# UNITED STATES PATENT AND TRADEMARK OFFICE

10/821,624

# Office Action Summary

**Claims 1-12, 14-20, 27, and 28 are rejected under 35 U.S.C. 102(b) as being anticipated by Valentini et al. US 4,069,819.**

PRIOR ART  
4,069,319  
FIG. 3

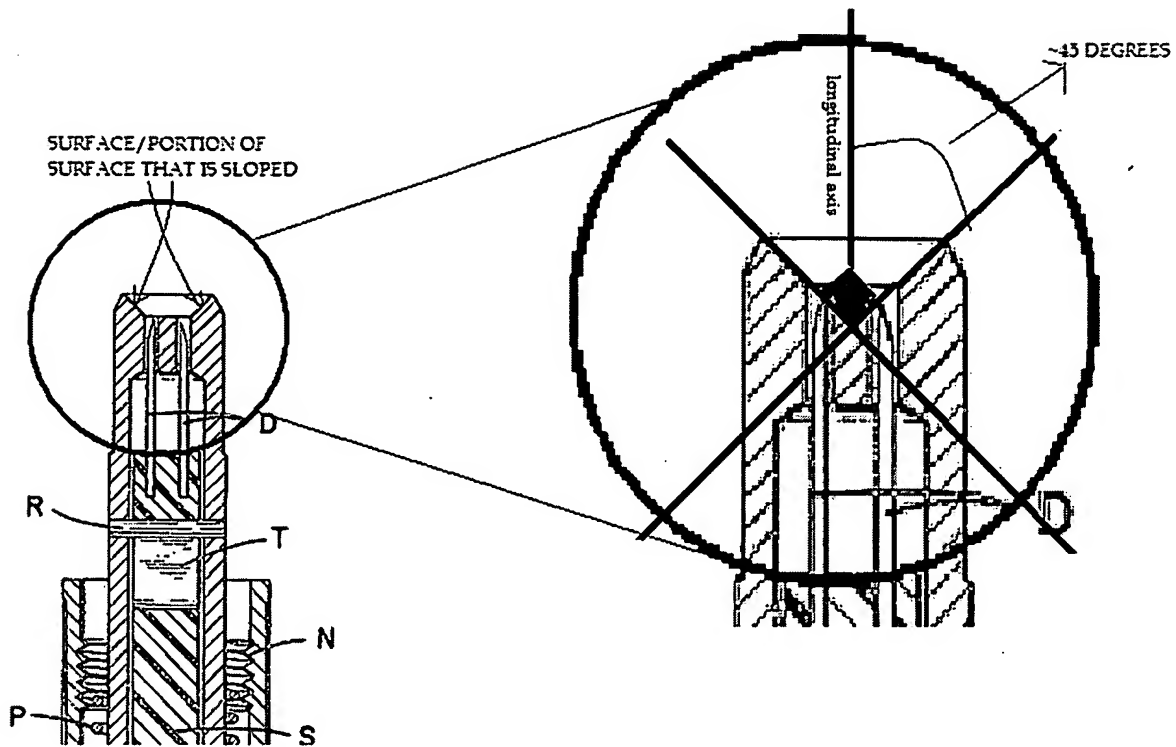
a puncturing mechanism (fig.3, M-T) within the housing, the puncturing mechanism comprising an alignment guide (L) and a puncture member (D), wherein the alignment guide comprises a surface (bevel depicted at one end of L, see labeled fig.3 attached below) adapted to contact the capsule while the puncture member is advanced into the capsule to create an opening (col.2 lines 65-68, col.3 lines 1-10) in the capsule, and wherein at least a portion of the surface is sloped at an angle which is less than 55 degrees relative to the longitudinal axis of the capsule (see labeled fig.3); and an end section (A) associated with the housing, the end section sized and shaped to be received in a user's mouth or nose so that the user may inhale through the end section to inhale aerosolized pharmaceutical formulation that has exited the capsule through the opening created in the capsule (col.3 lines 10-16).

**As to claim 2,** Valentini discloses wherein the surface is sloped at an angle, which is from 35 to 55 degrees relative to the longitudinal axis of the capsule (see labeled fig.3).

**As to claim 3,** Valentini discloses wherein the surface is sloped at an angle, which is from 37 to 50 degrees relative to the longitudinal axis of the capsule (see labeled fig.3).

**As to claim 4,** Valentini discloses wherein the surface is sloped at an angle of about 45 degrees relative to the longitudinal axis of the capsule (see labeled fig.3).

**As to claim 7,** Valentini discloses wherein the wherein the surface is sloped at an angle which less than 55 degrees relative to the longitudinal axis of the puncture member (see labeled fig.3).

**As to claim 8,** Valentini discloses wherein the surface is sloped at an angle which less than 55 degrees relative to the longitudinal axis of the chamber (see labeled fig.3).

**As to claim 9,** Valentini discloses wherein the wherein the surface is sloped at an angle which less than 55 degrees relative to an inhalation direction (see labeled fig.3).

**As to claim 11,** Valentini discloses wherein the wherein the surface is sloped at an angle which less than 55 degrees relative to the direction of movement of the surface (see labeled fig.3).

**As to claim 12,** Valentini discloses wherein the surface comprises one or more protrusions and wherein the one or more protrusions (see labeled fig.3) are adapted to contact the capsule (col.2 lines 65-68).
